City of Redmond
2024 Water System Plan

Revised/Finalized: May 2025

Jeffrey M. Hansen, P.E.
HDR Engineering, Inc.
905 Plum Street SE, Suite 200, Town Square 3
Olympia, WA 98501-1516

Figure 2-1. Retail Service Area and Adjacent Purveyors

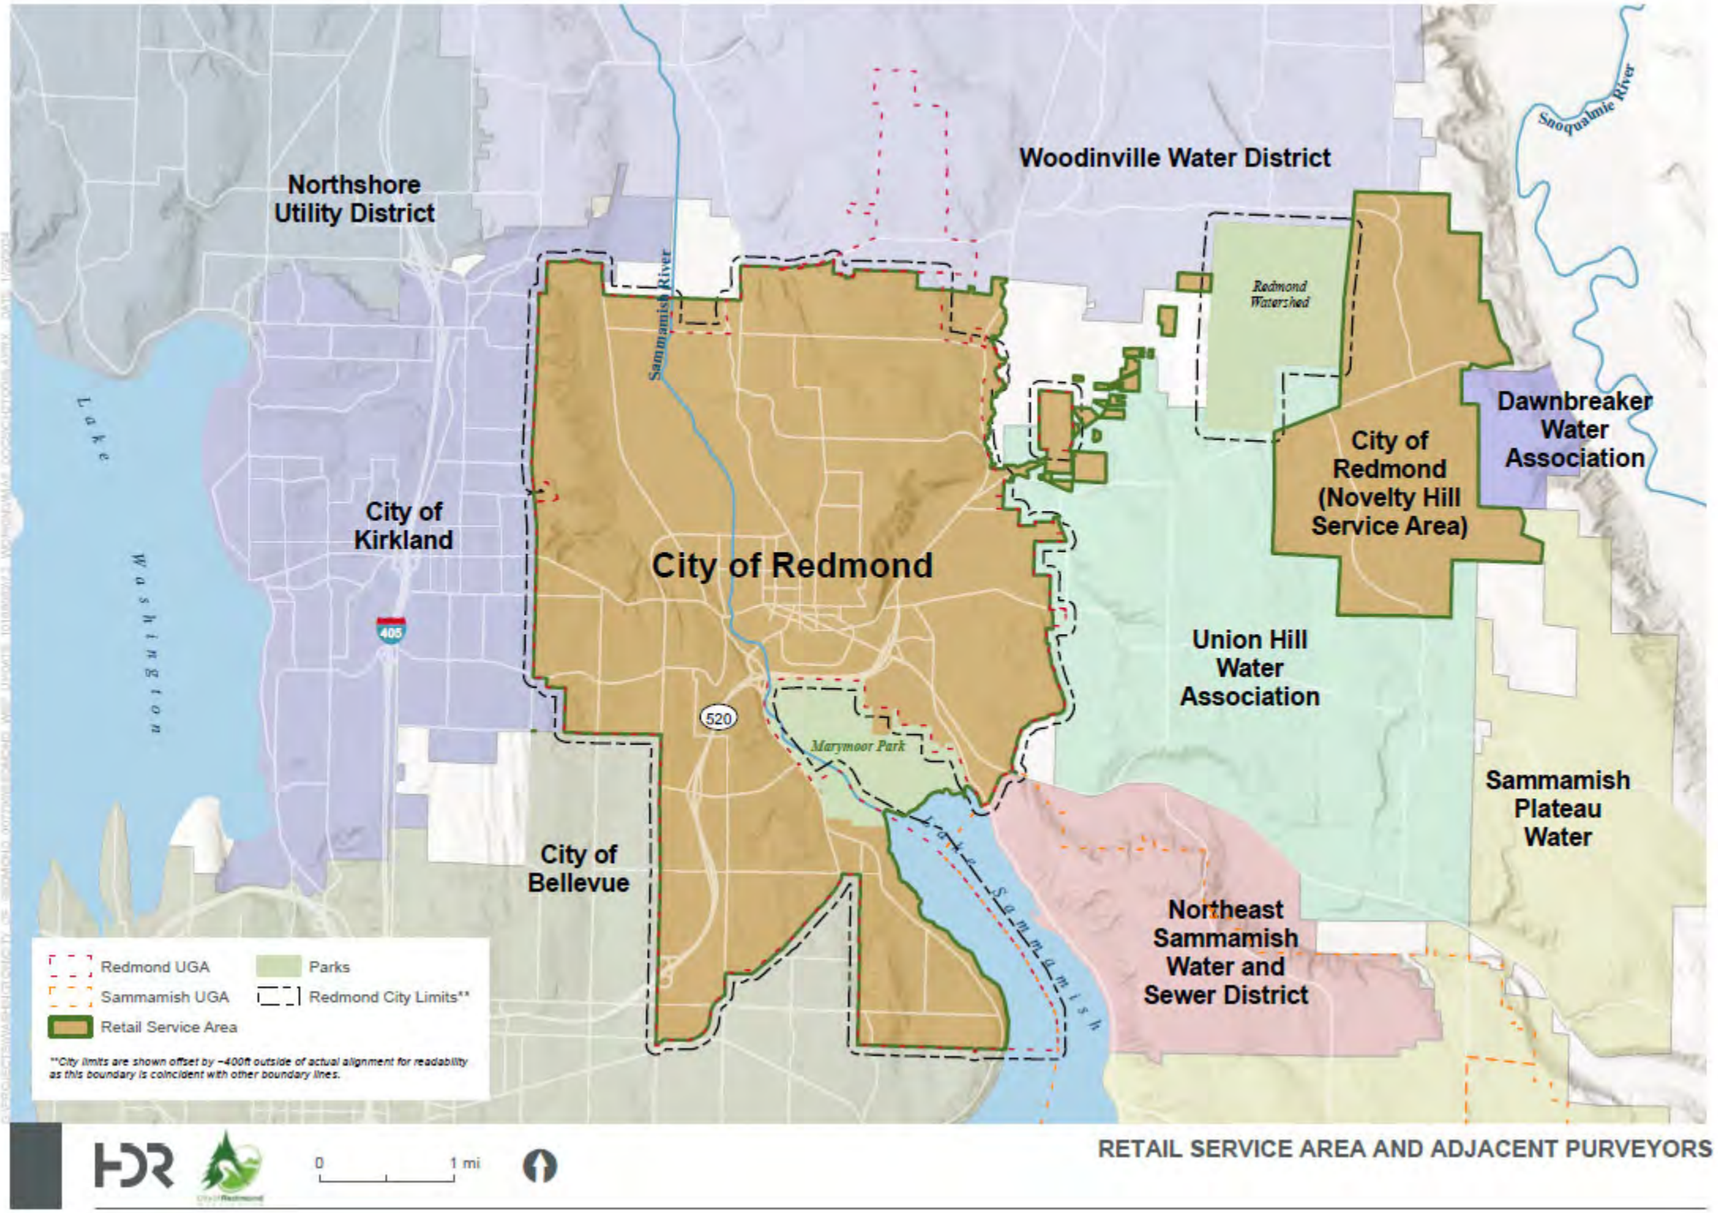
Comment No.	Comment	Response
1	Service Area Boundary: Please correct the City of Kirkland Retail Service Area boundary shown on Figure 2-1. Please see the encircled area on the attached Kirkland Existing Water System Map.	Figure has been revised per the comment.
2	South and North Rose Hill Ownership Percentages. Table 3-5, Page 3-35, shows Redmond's contractual ownership of the South and North Rose Hill Reservoirs as 21.5% and 29.2%, respectively. It appears these ownership percentages are from the 1993 Rose Hill Assumption Agreement. The 1997 Interlocal Operations and Maintenance Agreement, amended in 2005, shows that Redmond owns 29.4% of the Rose Hill South Reservoir and 34% of the North Rose Hill Reservoir. The percentage used to define the contractual storage available to the City of Redmond may affect the analyses and text contained in Chapters 10 and 12. Please see the highlighted portions of the attached Interlocal Operations and Maintenance Agreement.	Table 3-5 has been updated, and associated updates in other chapters have also been made.

5) Figure 2-1. Retail Service Area and Adjacent Purveyors. It is difficult to identify the Retail Service Area as the UGA and City Limits overlap with it. Can the map key be revised to identify the Retail Service Area more clearly in conjunction with other map attributes?

6) Section 2.2.1. Novelty Hill Service Area. While Figure 2-1 shows that the Novelty Hill Service Area is not contiguous/detached from other City service areas, the text does not explain why the City was the most appropriate water purveyor to provide water service to the residential developments in unincorporated King County. It would be beneficial to clarify when and why the City expanded its

8) Section 2.3.1. 2016 King County Comprehensive Plan. In review of Figure 2-1, it appears the City's service area encompasses unincorporated areas beyond the Novelty Hill Service area; however, the text doesn't appear to acknowledge this. While there is reference to the UGA, does the City's service area include any unincorporated Rural areas? It appears that Figure 2-3 shows a small portion of the service area being designated Rural area. Please clarify.

6	Section 2.2.1. Novelty Hill Service Area. While Figure 2-1 shows that the Novelty Hill Service Area is not contiguous/detached from other City service areas, the text does not explain why the City was the most appropriate water purveyor to provide water service to the residential developments in unincorporated King County. It would be beneficial to clarify when and why the City expanded its service area to service these developments. This explanation may justify the irregular service area boundary.	Text added to section 2.2.1 to broadly describe the history.
7	Section 2.3.1. 2016 King County Comprehensive Plan. The text provides a detailed description of the County's Comprehensive Plan policies and identifies adopted land use designations on Figure 2-3., however, it is appropriate to also provide the acreage associated with each land use designation and identify the development status of the acreage (i.e., vacant, developed, underdeveloped).	A new table (Table 2-1 has been added with this information.

8	Section 2.3.1. 2016 King County Comprehensive Plan. In review of Figure 2-1, it appears the City's service area encompasses unincorporated areas beyond the Novelty Hill Service area; however, the text doesn't appear to acknowledge this. While there is reference to the UGA, does the City's service area include any unincorporated Rural areas? It appears that Figure 2-3 shows a small portion of the service area being designated Rural area. Please clarify.	Yes, small portions of the RSA to the east and northeast serve rural unincorporated King County. Text was added in section 2.4.1 (Retail Service Area Boundaries) to further describe these areas within the RSA in unincorporated King County, and that policy UT-4 in the City's comprehensive plan described how rural water service will be provided.

Figure 2-4. Redmond Comprehensive Land Use Plan

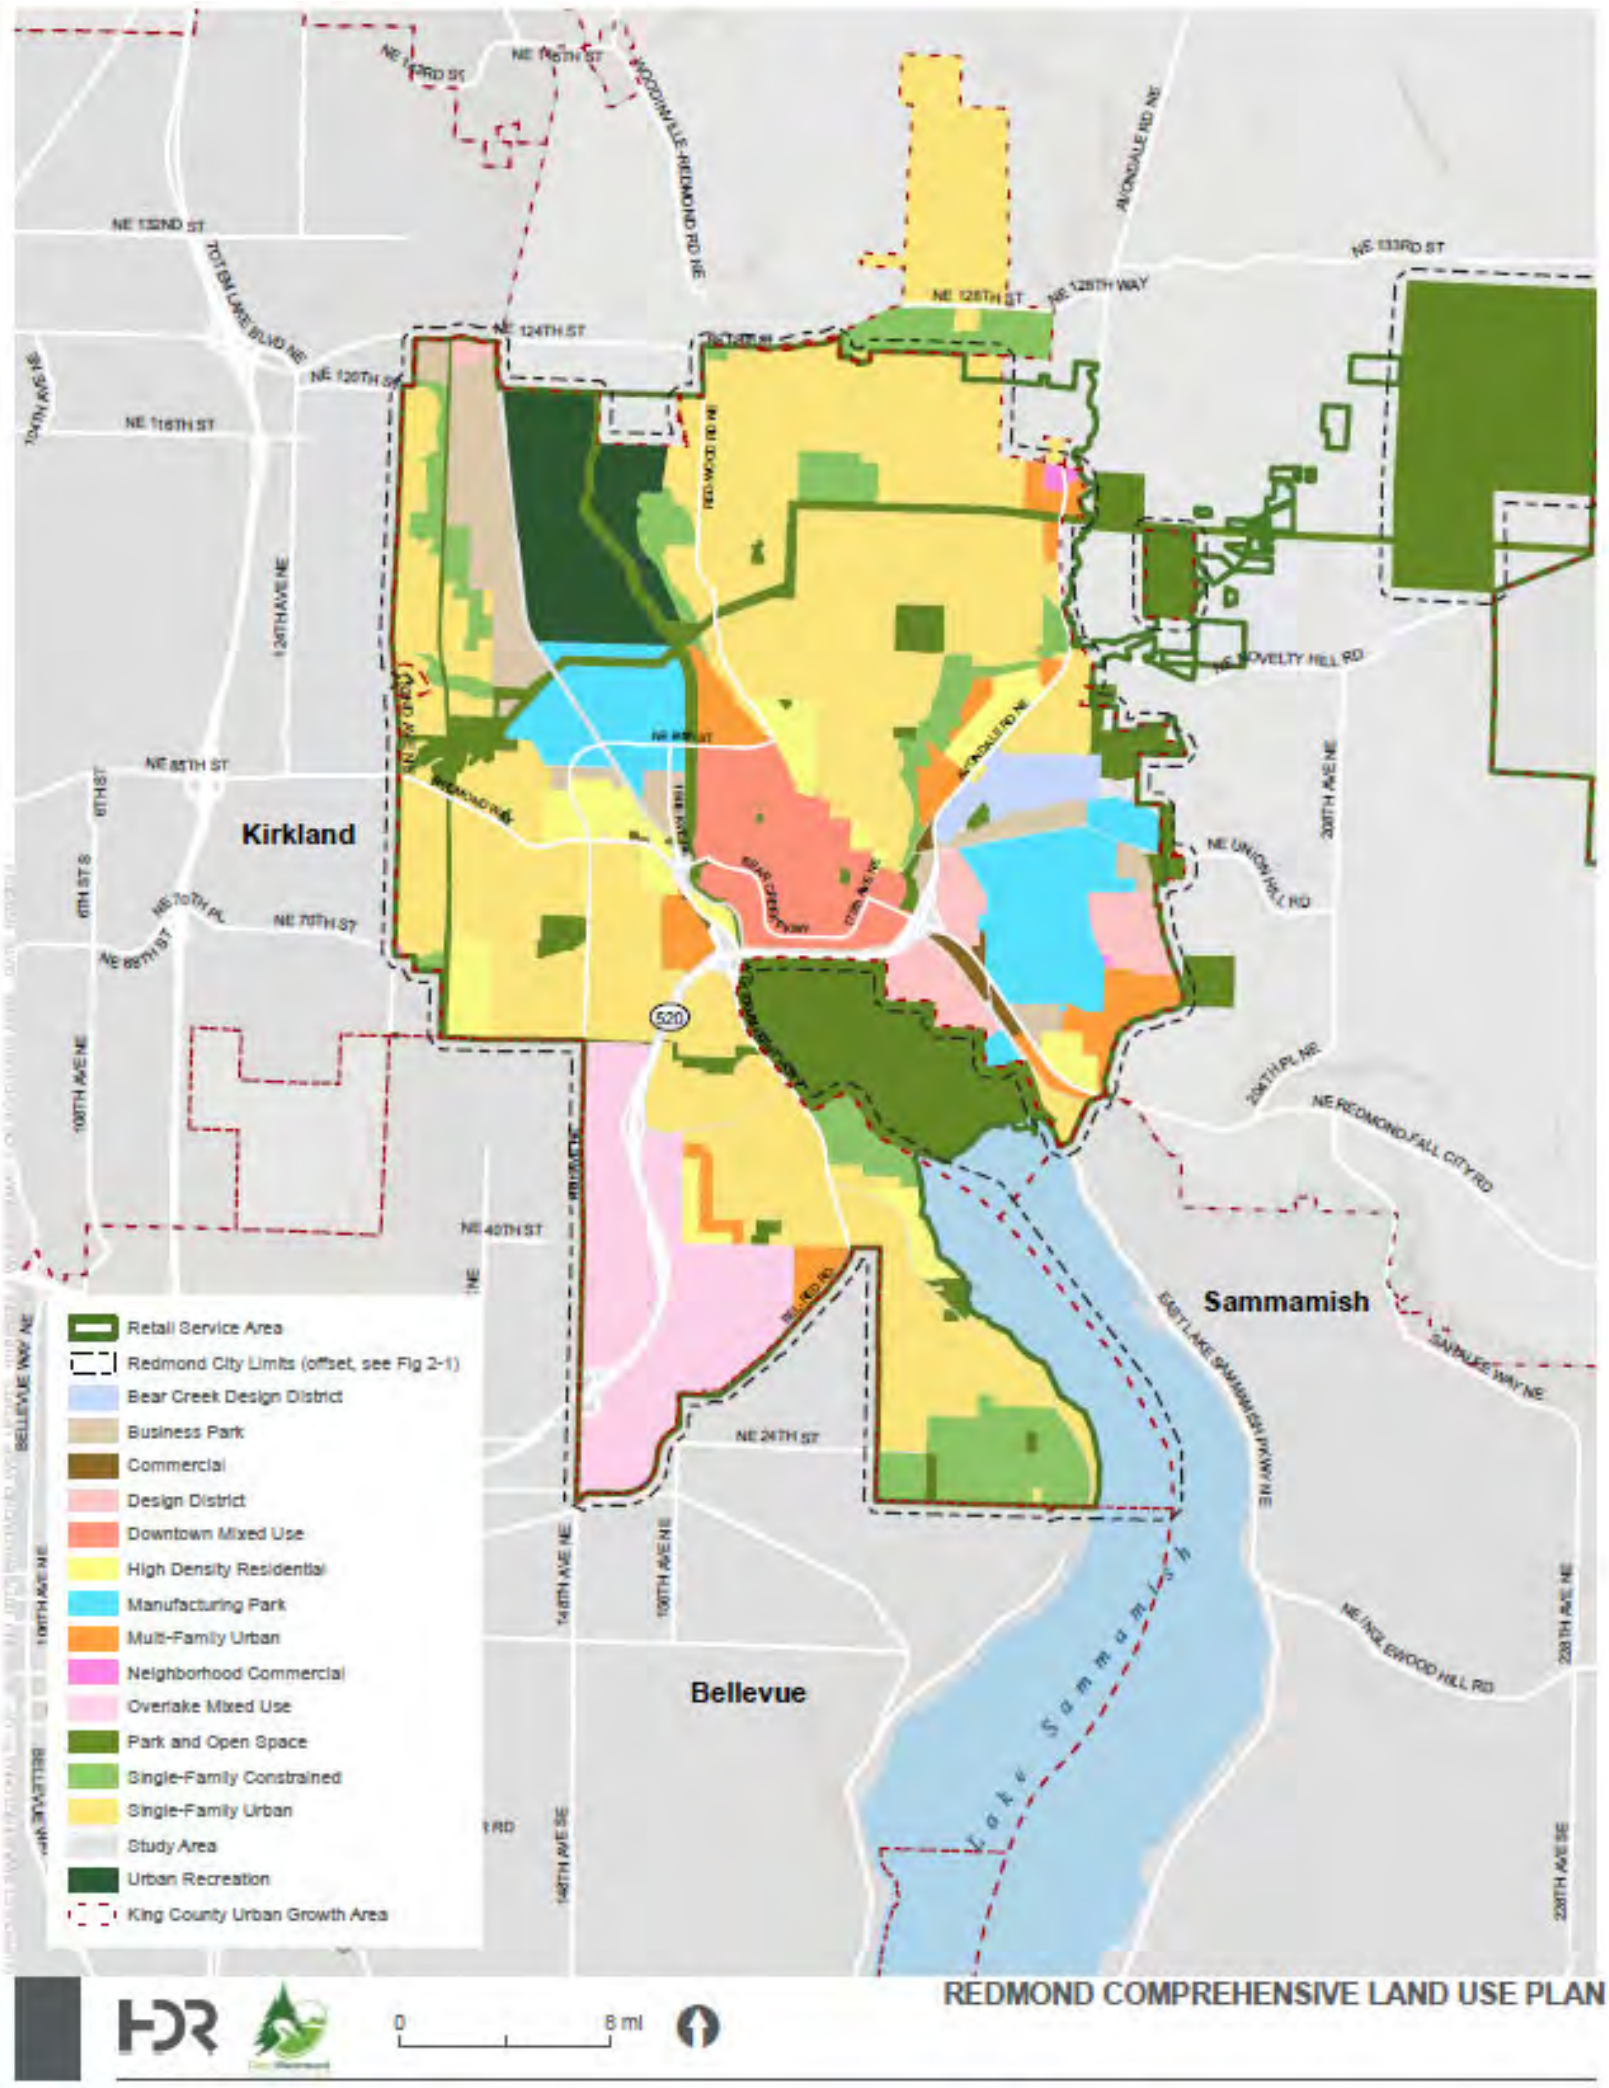
10) Figure 2-4 Redmond Comprehensive Land Use Plan. It is difficult to identify the Retail Service Area as the UGA and City Limits overlap with it. Can the map key be revised to identify the Retail Service Area more clearly in conjunction with other map attributes?

10	Figure 2-4 Redmond Comprehensive Land Use Plan. It is difficult to identify the Retail Service Area as the UGA and City Limits overlap with it. Can the map key be revised to identify the Retail Service Area more clearly in conjunction with other map attributes?	Figure revised, as noted in a previous response.
11	Section 2.4.1 Retail Service Area Boundaries. The text states that the City doesn't anticipate any major changes to its retail service area in the immediate future, however, the service area may be expanded to provide service to areas annexed into the City. While Figure 2-1 indicates that the unincorporated UGA adjacent to the City is not within the City's Retail Service Area, adding text to this section would clarify this situation. The text should also acknowledge that if the City expands its Retail Service Area, the water system plan would need to be amended to modify Figure 2-1 and update other appropriate text.	All the Redmond UGA that is not served by the City is already served by other purveyors. Added text to 2.4.1 indicating that the service area may be expanded to provide service to areas annexed into the City in the future <u>that are not currently served by another purveyor</u>. A statement was added that changes to the RSA would require a plan amendment and approval.
